**PRE-APPLICATION CONFERENCE: La Center Multi-family (2014-003-PAC)  
Tuesday, June 13, 2017 – 4:00 PM**

**PROJECT INFORMATION**

- Proposal:** The applicant proposes to construct 72 medium density housing units.
- Location:** 1518 NE Lockwood Creek Road, La Center, WA; #64 SEC 2 T4N R1EWM 3 A (PIN 209083000) and #4 SEC 2 T4N R1EWM 2.17 A (PIN 209044000); 225, 205 S.F.

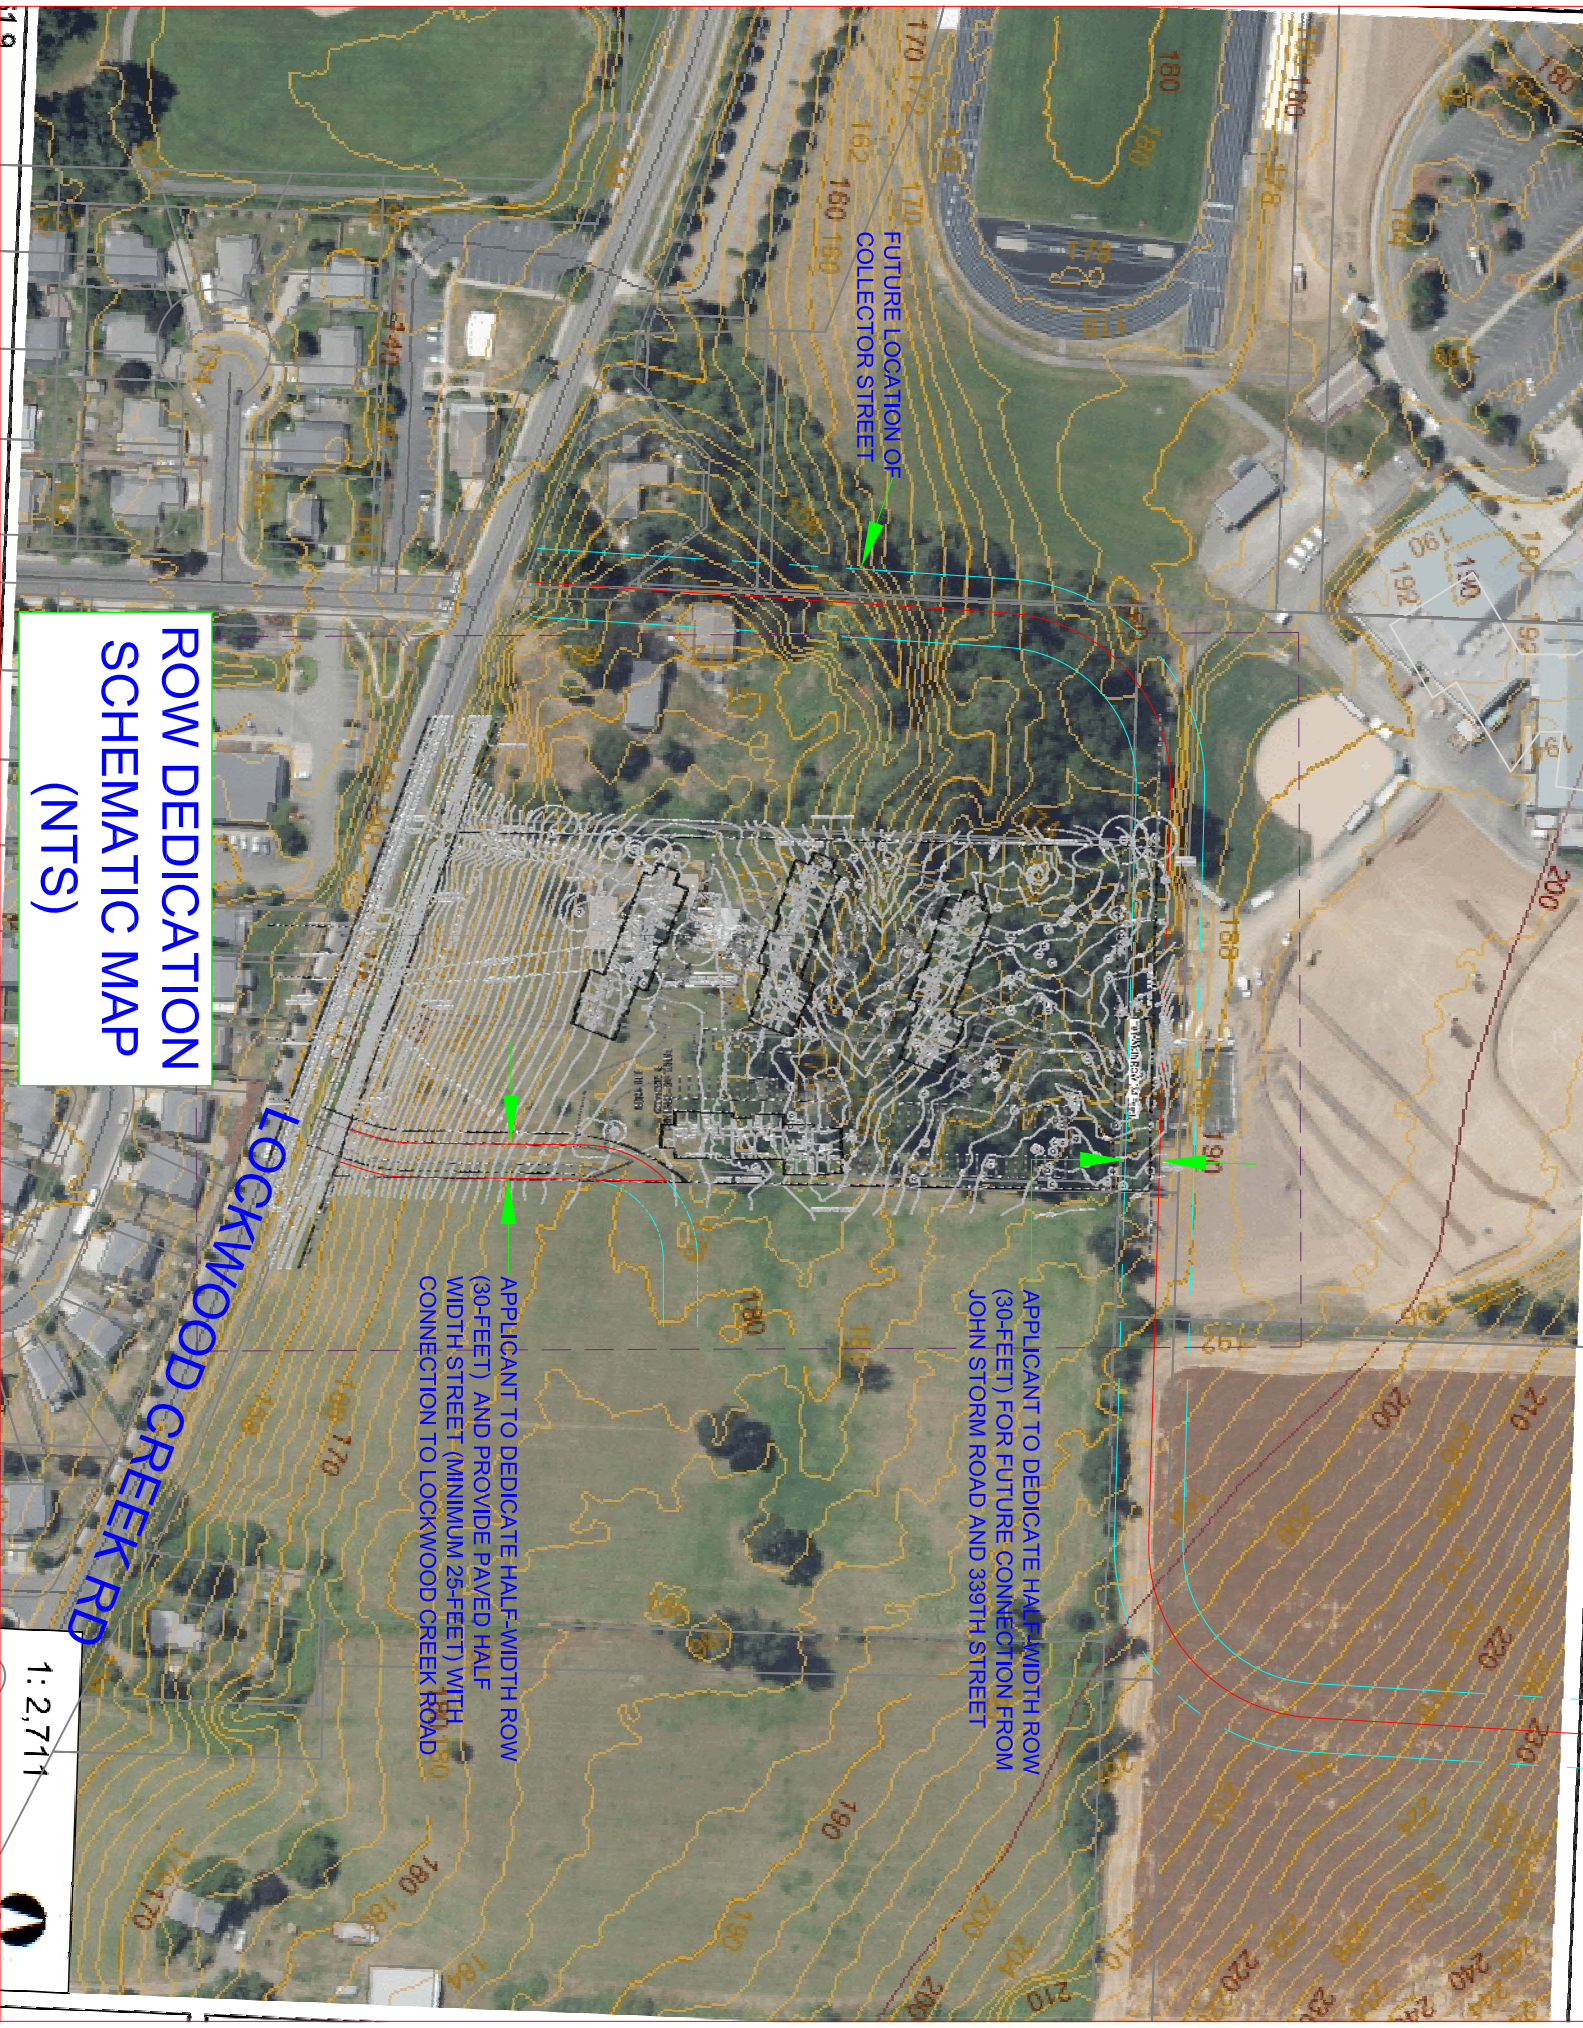
APPLICANT TO DEDICATE HALF-WIDTH ROW  
(30-FEET) AND PROVIDE PAVED HALF  
WIDTH STREET (MINIMUM 25-FEET) WITH  
CONNECTION TO LOCKWOOD CREEK ROAD
